Waukivory Pilot Project

Request to vary the approved activity

Prepared for AGL Upstream Investments Pty Ltd
April 2015

Report J13005RP1 | Prepared for AGL Upstream Investments Pty Ltd | 15 April 2015

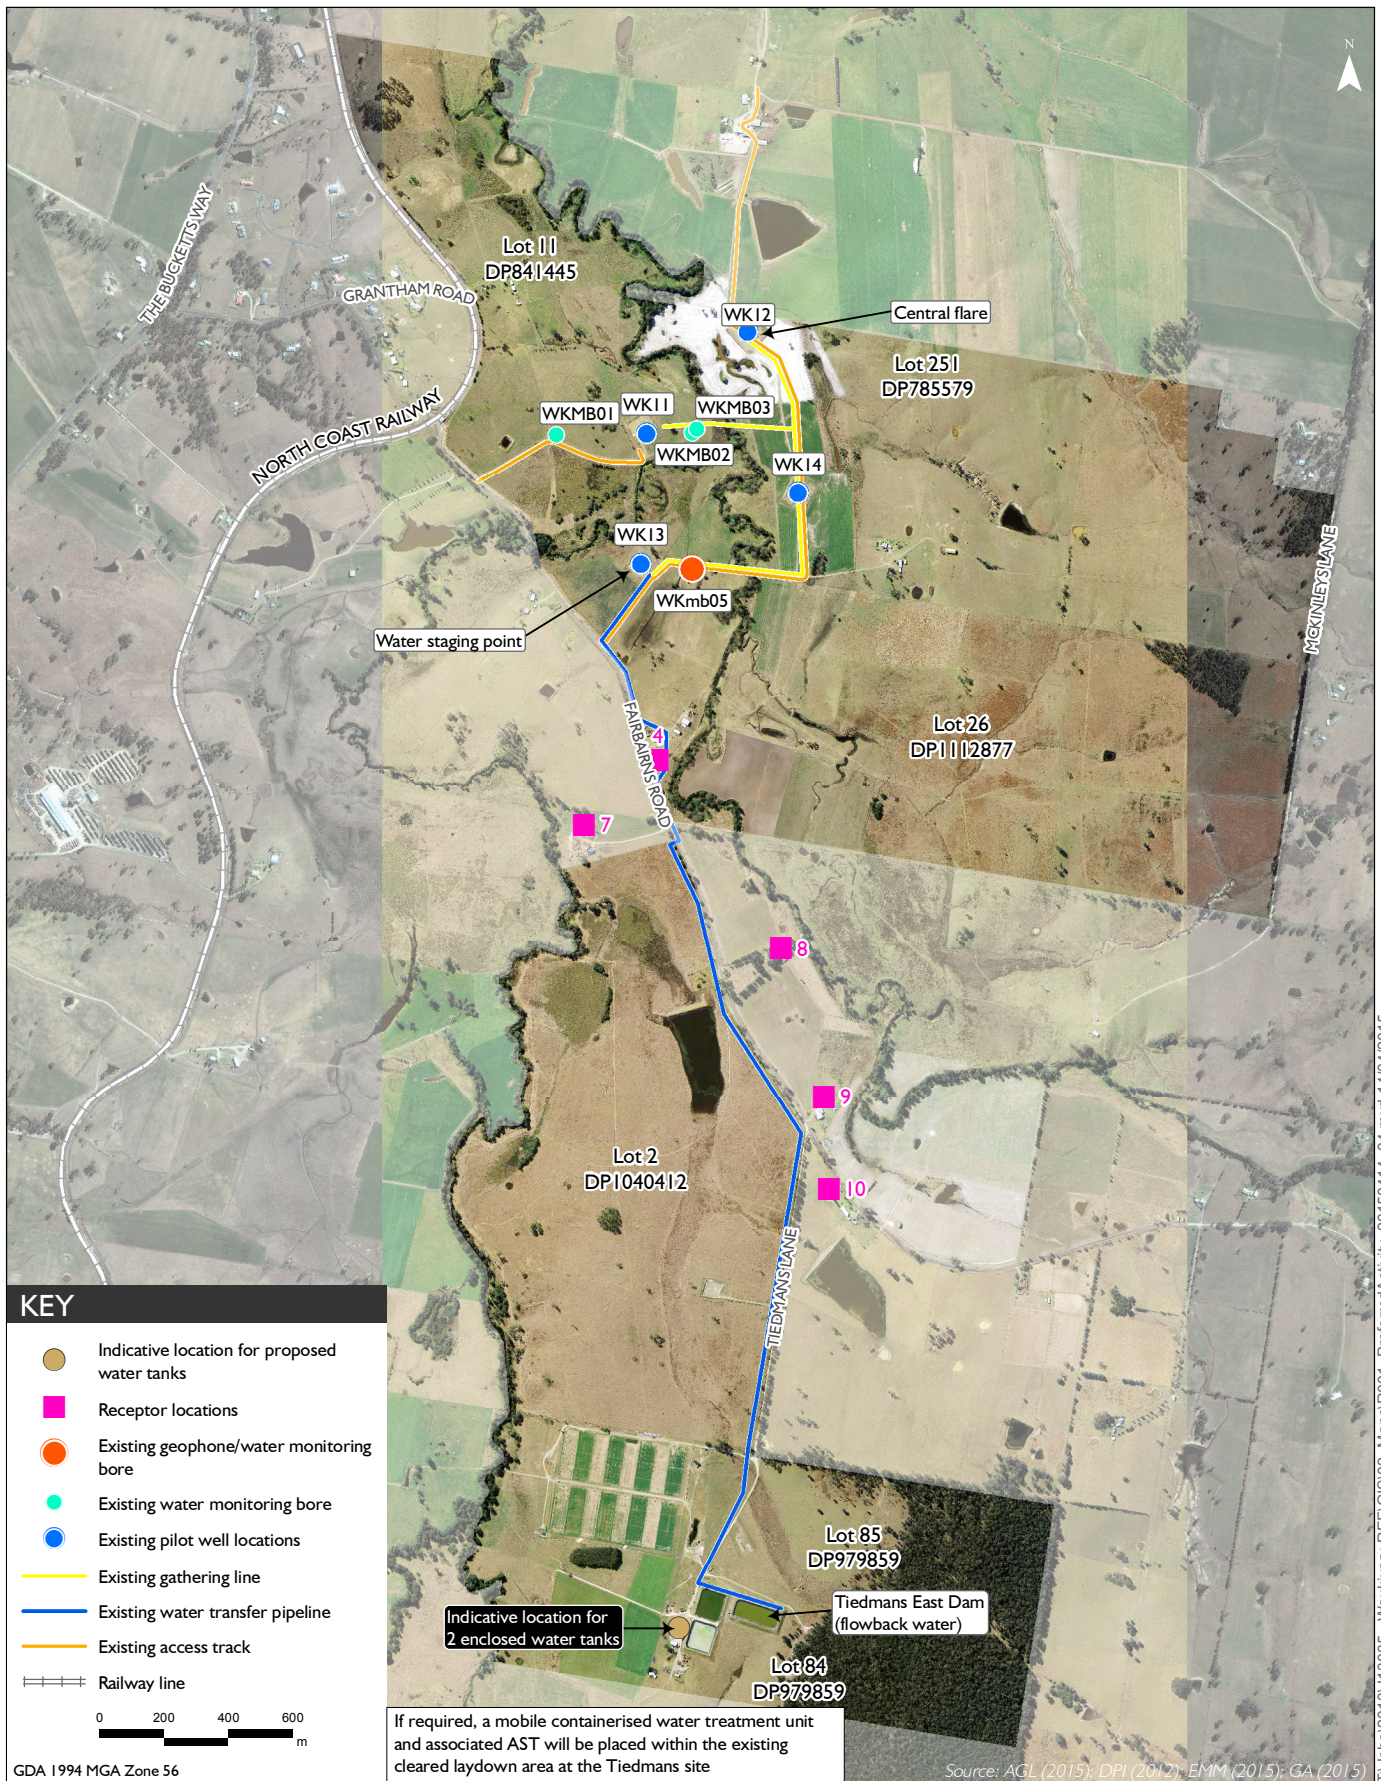
In order to ensure the overall objective of the Project's flowback stage is met, and to further enhance certainty and security of the management of flowback water for its lawful disposal, AGL proposes to vary the approved activity as set out below. Key components of the proposed variation are shown in Figure 1 and flow chart shown in Appendix A.

- **Additional pressure test on existing (approved) pipeline:** Carry out further pressure test to existing approved water flow line from AST 2 to TED. Record results of pressure test.
- **Existing stored flowback water:** Pump existing stored and tested flowback water from AST 2 to the TED at the Tiedmans site through the existing approved pipeline (approximately 600,000 litres).

- **New loading facility at TED:** Installation of a temporary tanker loading facility consisting of two enclosed topped, bunded tanks (57,000 L capacity each) and associated pumps and pipe infrastructure at TED for transportation of flowback water by road tankers from the TED to a lawful offsite disposal facility.

- The bunded tanks would be positioned adjacent to the dams (refer to Figure 1) to facilitate pumping from the dam into tankers.
 - Flowback water would be characterised prior to lawful disposal. When pumping to TED is occurring, characterisation would occur in the enclosed tanks. However when pumping to TED is not occurring, this characterisation would occur within the TED (refer to Section 2.1 for further detail).

The proposed variation involves the pumping of flowback water from AST 2 to the Tiedmans site into the existing TED via the existing approved pipeline (refer to Figure 1) following an additional pressure test on the existing approved pipeline between AST 2 and the TED. The TED is double-lined with HDPE and was constructed by NSW Government's Soil Conservation Service in 2013.

Two enclosed and bunded tanks with a capacity of approximately 57,000 litres each (accommodating 110% secondary containment capacity within the duck pond) would be installed adjacent to the TED within an existing cleared laydown area (refer to Figure 1). The tanks would be managed to ensure the capacity of 57,000 litres is not exceeded, ensuring the duck pond can capture 110% of the contents of one tank.
